APICAL INDUSTRIES, INC.
dba DART AEROSPACE

ENGINEERING CHANGE NOTICE NO.

DWG NO. 647.7700

DWG TITLE: STRUT ASSY

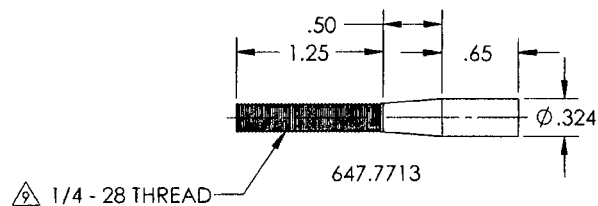
ENGINEERING CHANGE NOTICE NO. 05397		SHEET 1 OF 1	
DWG NO. 647.7700	REV: A	PREPARED BY T. CROSS	DATE: 05/02/16
DWG TITLE: STRUT ASSY			EFFECT ON DWG ☐ INC. ☒ UNINC.
APPROVED BY: ENGR <i>[Signature]</i>	MFG <i>[Signature]</i>	QC <i>[Signature]</i>	EFF: CURRENT ORDER
REASON: REVISED DIMENSION			ECR: 16-028
TRANSACTION CODES (TC): A-ADD C-CREATE R-REVISE D-DELETE			ACTION LIST: 1.

SHEET 2, ZONE D4 IS:

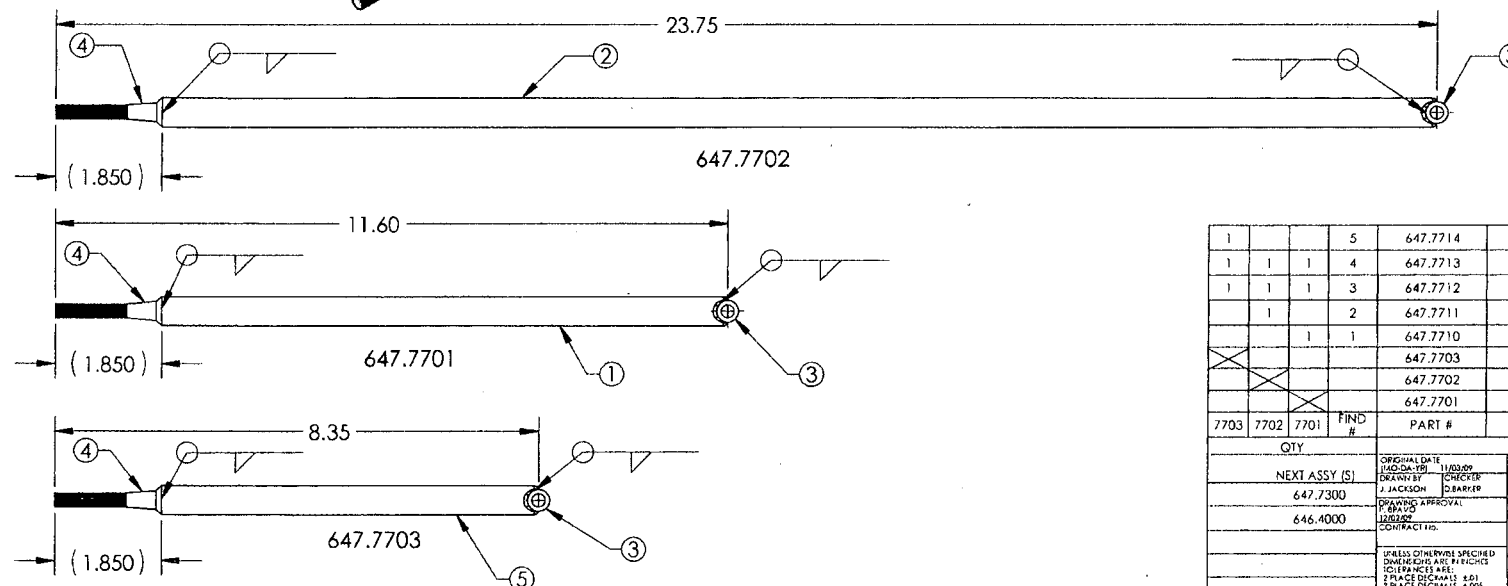
REASON: REVISED FINISH CALLOUT AS PER ECR 15-209

SHEET 1, NOTES IS:

- 1 MATERIAL: 4130 STEEL PER AMS-T-6736, .50" OD, .083" WALL THK.
- 2 MATERIAL: 4130 STEEL PER AMS-T-6736, .375" OD, .075" WALL THK.
- 3 MATERIAL: 4130 STEEL PER AMS-T-6736, .324" OD.
- 4 FINISH: PRIME IAW MIL-P-2337J TYPE I CLASS N; 1-2 MIL MAX
5. DEBURR AND BREAK ALL SHARP EDGES
6. IDENTIFY IAW MPP-120.
- 7 WELD IAW MIL-STD-2219. TIG WELD WITH FILLER ROD
- 8 FINISH: CAD PLATE IAW QQ-P-416F CLASS I TYPE II
- 9 MASK THREAD PRIOR TO FINISH
